Document Number:	REV:
		<b>VIBE CONTROLLER</b>	
TITLE: <b>edge-lord-2000</b>	Date: 5/17/22 10:18 AM	Sheet: 1/1

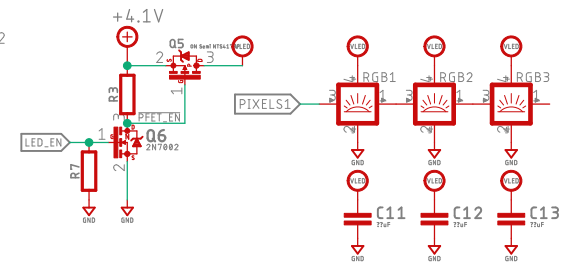
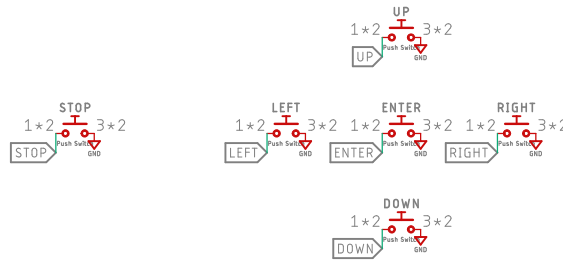
- change button pins to use input only pins.
- change MOT3 MOT4 to use non-SCK/MO pins.
- MOTORS connector channel order should be reversed, should go left to right.

- MOT2 and MOT3 don't work as they were routed onto INPUT only pins. Cut traces and moved to MO(18) and MI (19) pins.
- But SCK has signal on it during programming. Not for outputs. (or maybe pixel)
- Rev.B Move buttons to input only pins and use output pins (non-SCK) for motors.
